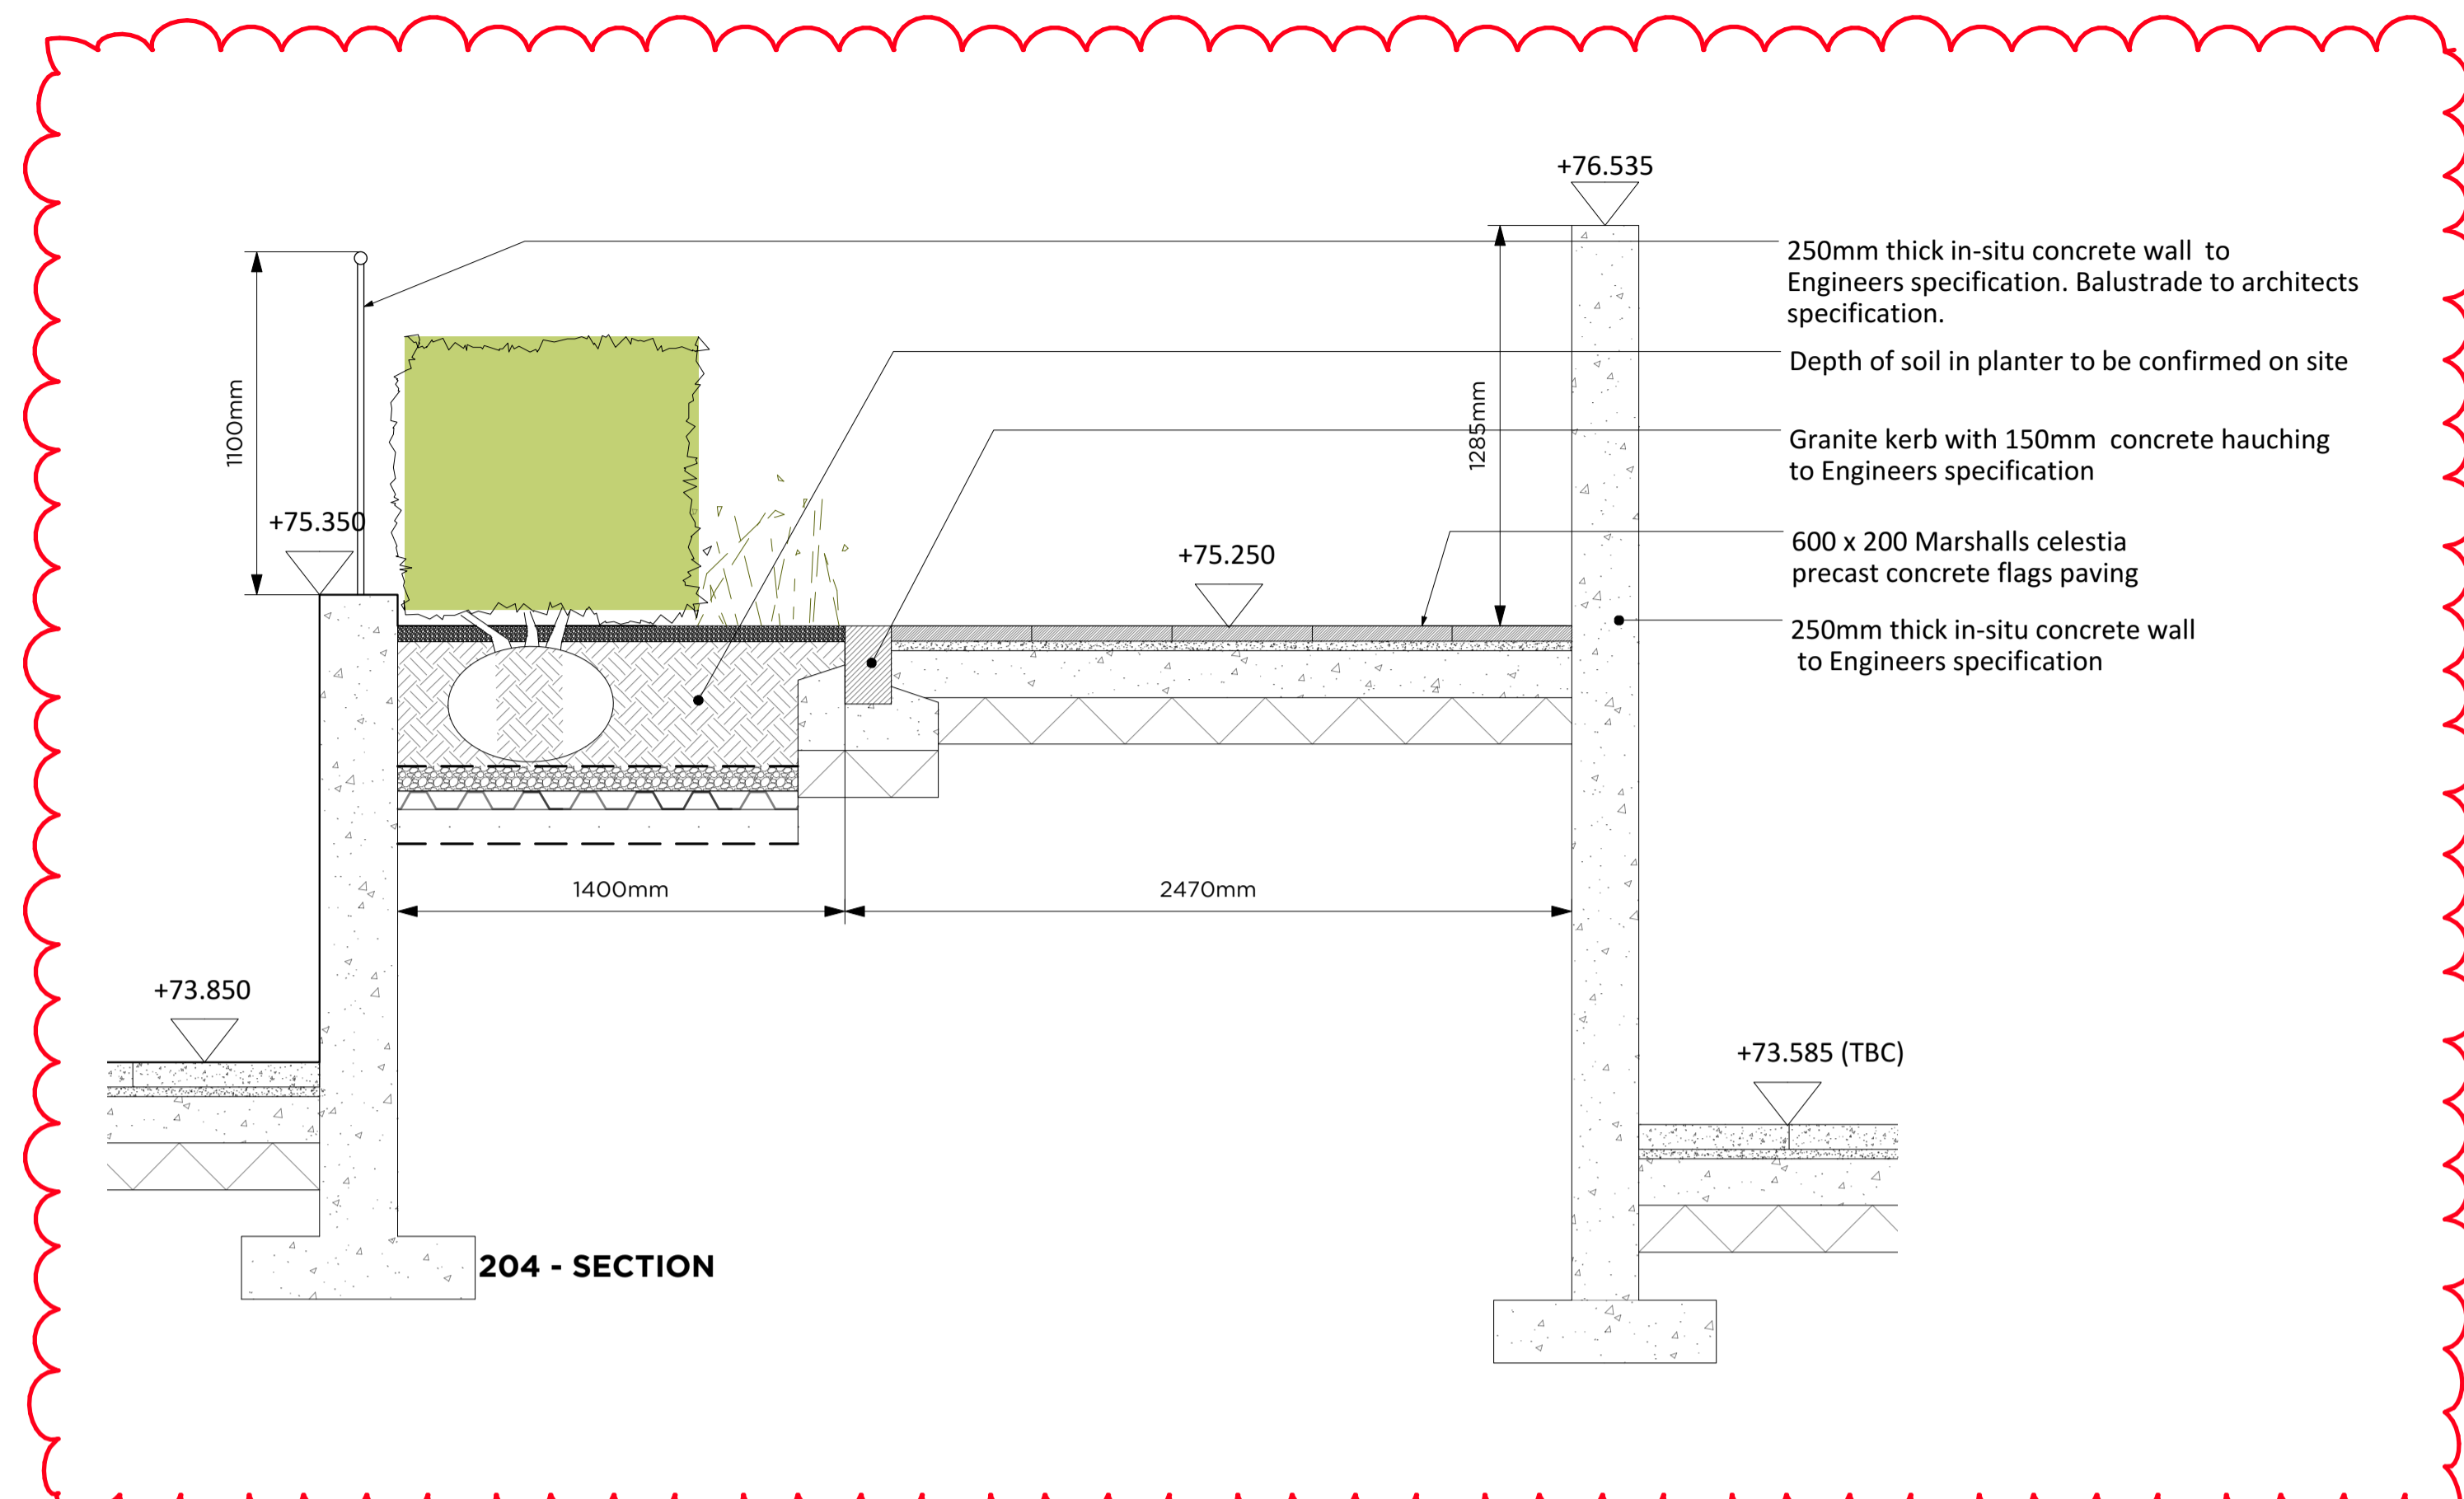
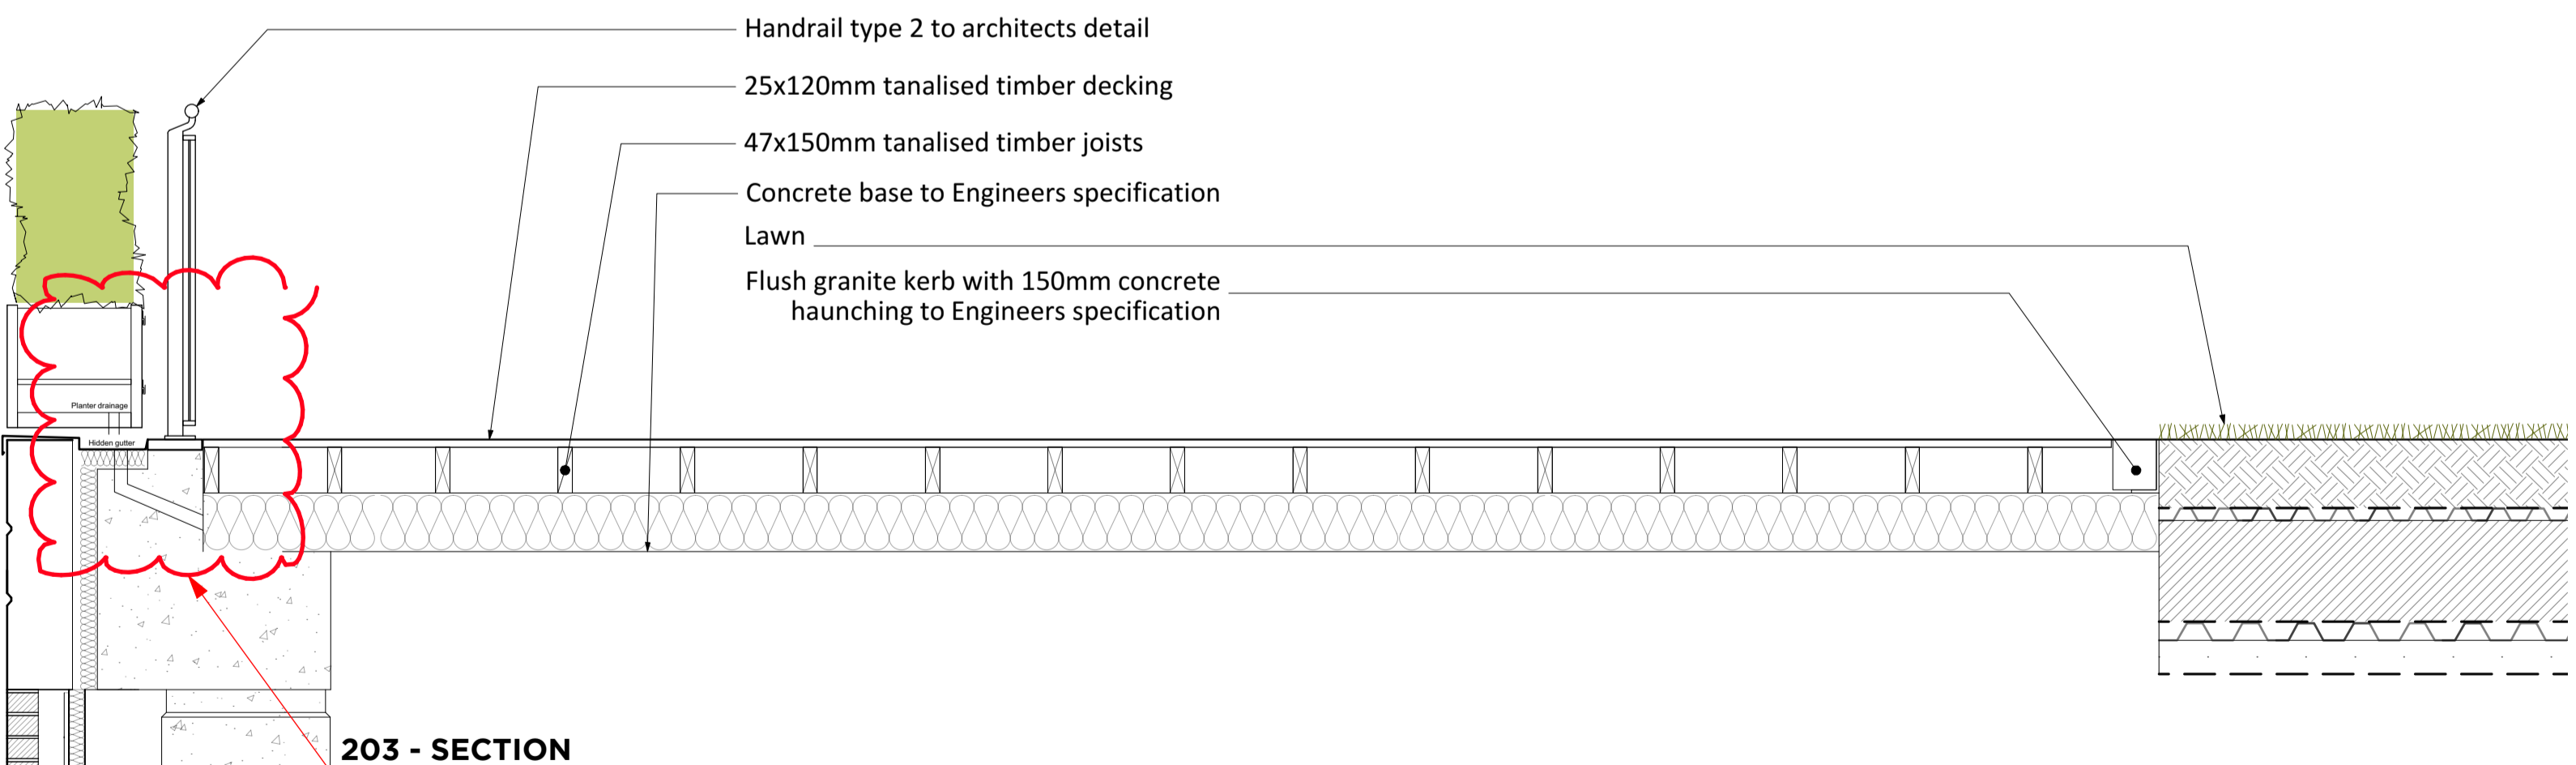
10. Width of planting/path revised. height of wall adjusted.
Handrail added to the side of the ramp

11. Width of planting/path revised. height of wall adjusted.
Handrail added.

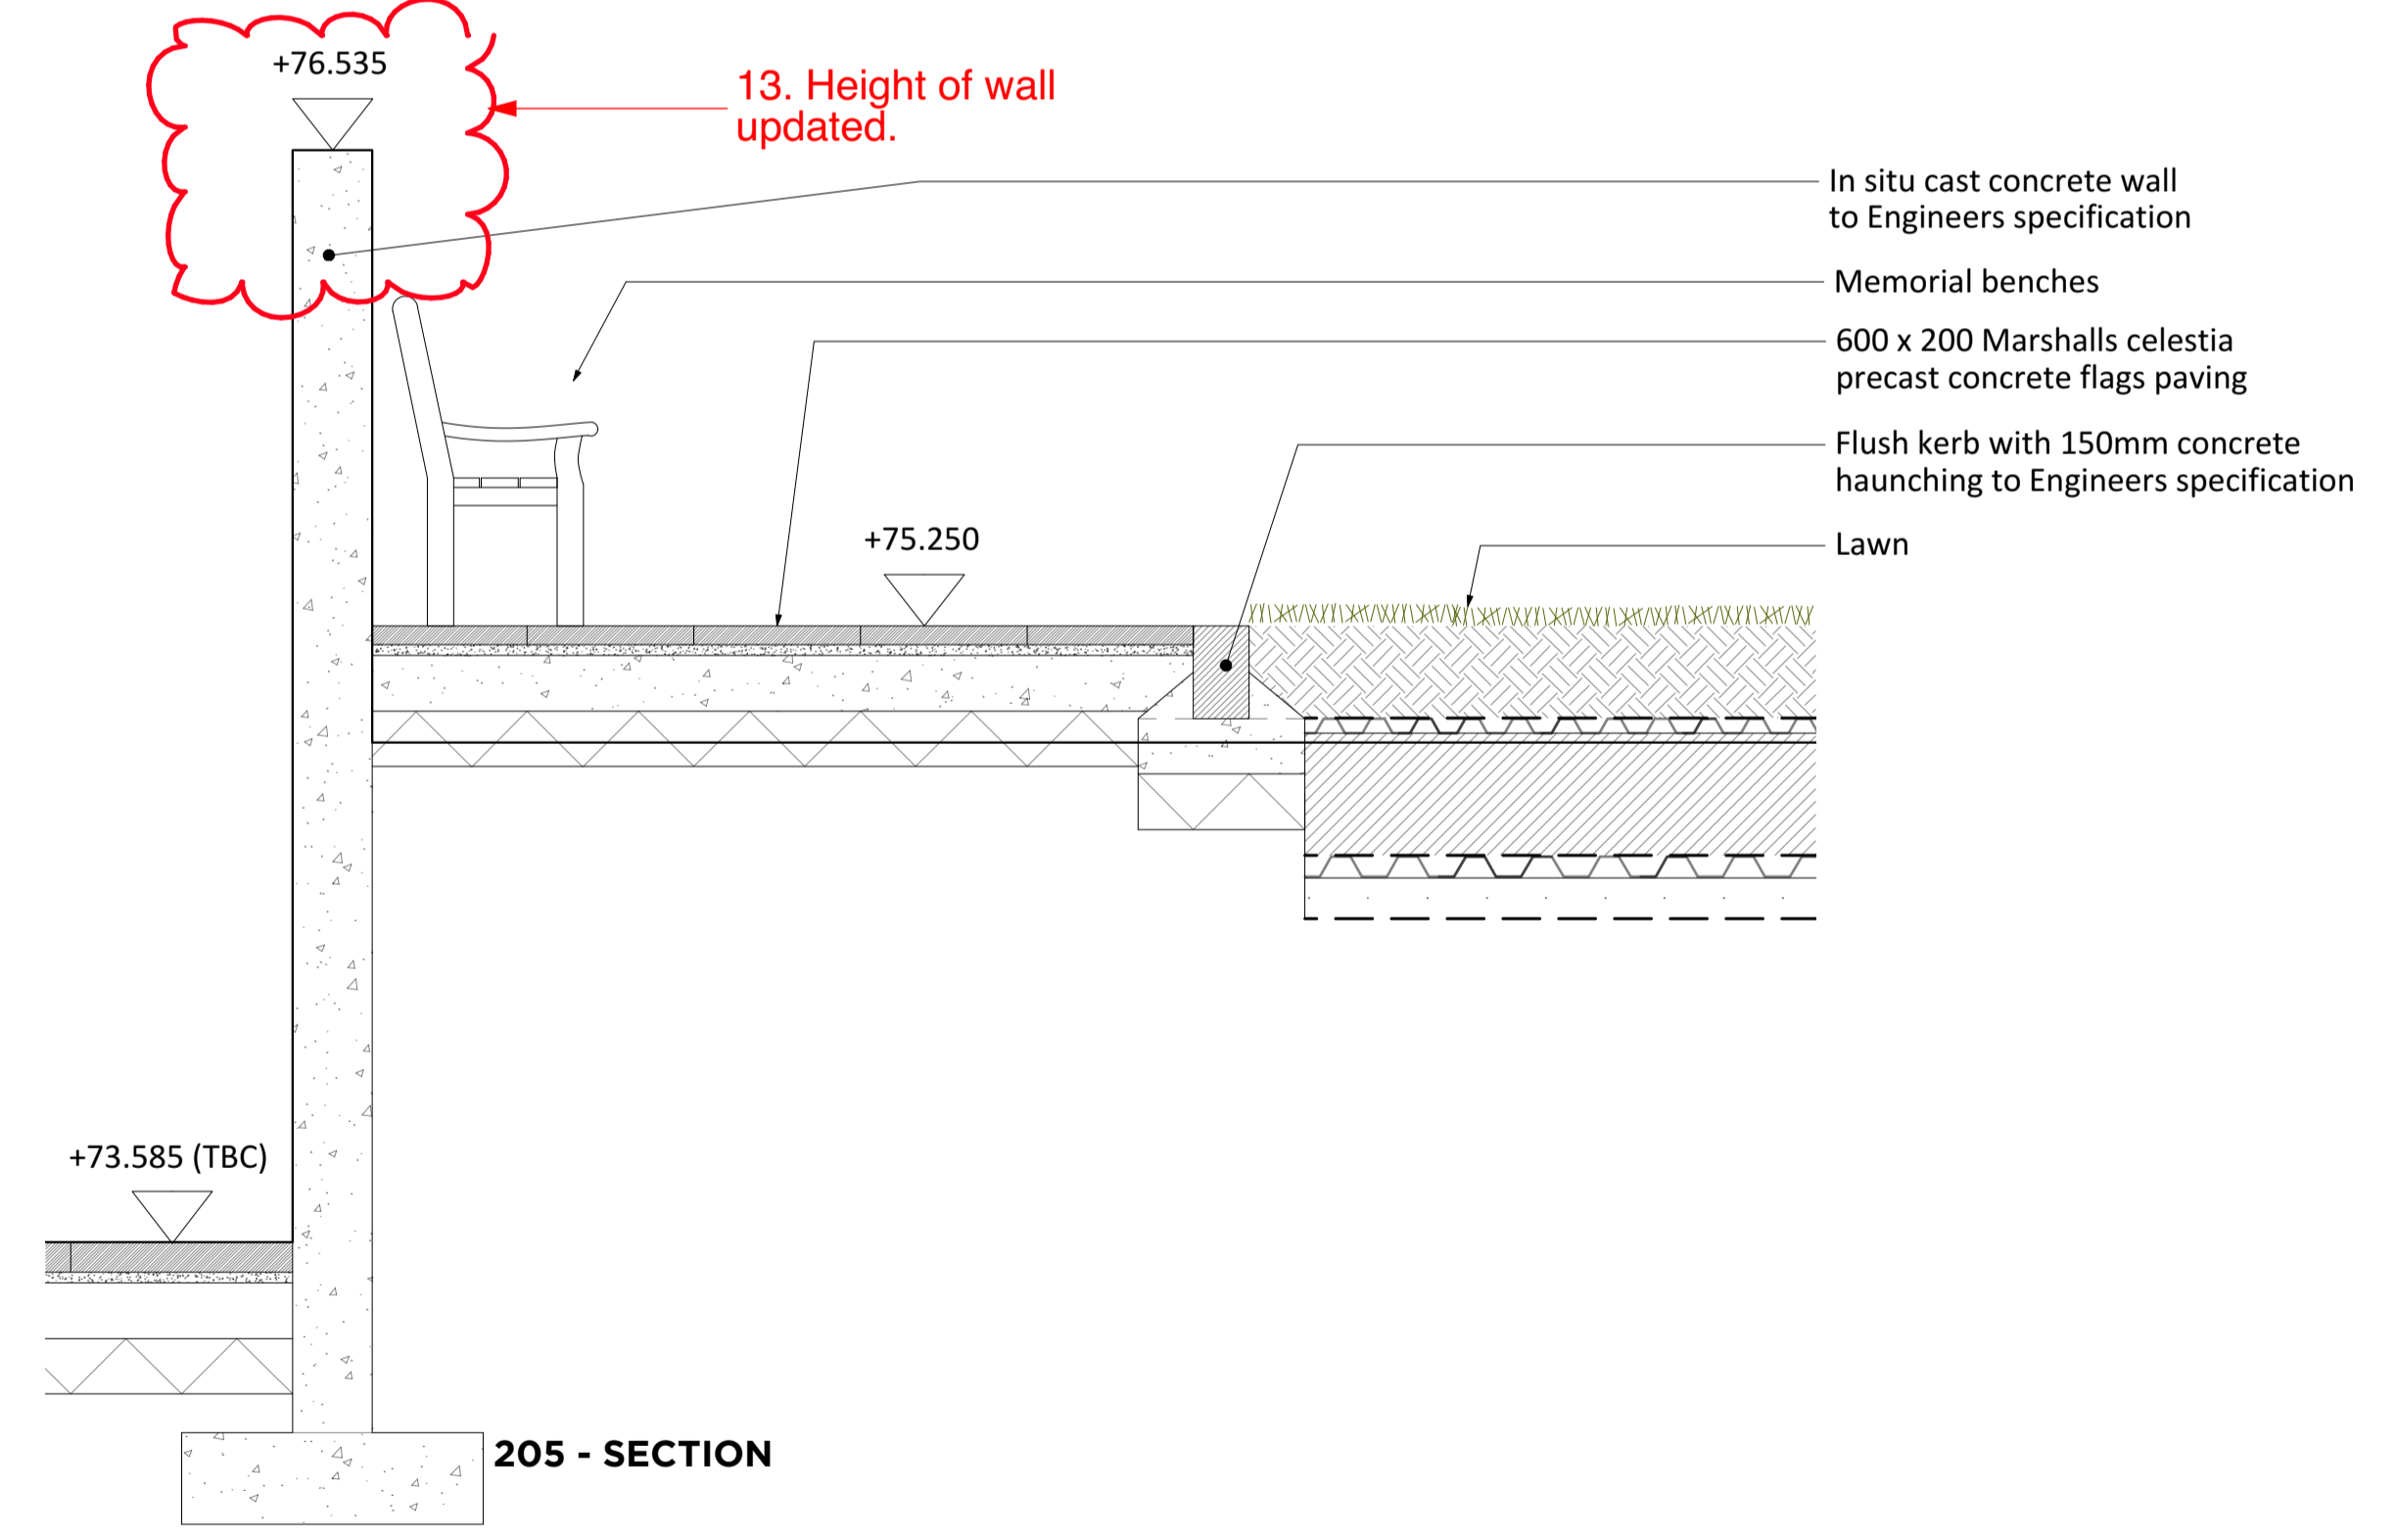
12. Concrete upstand removed.

13. Height of wall updated.
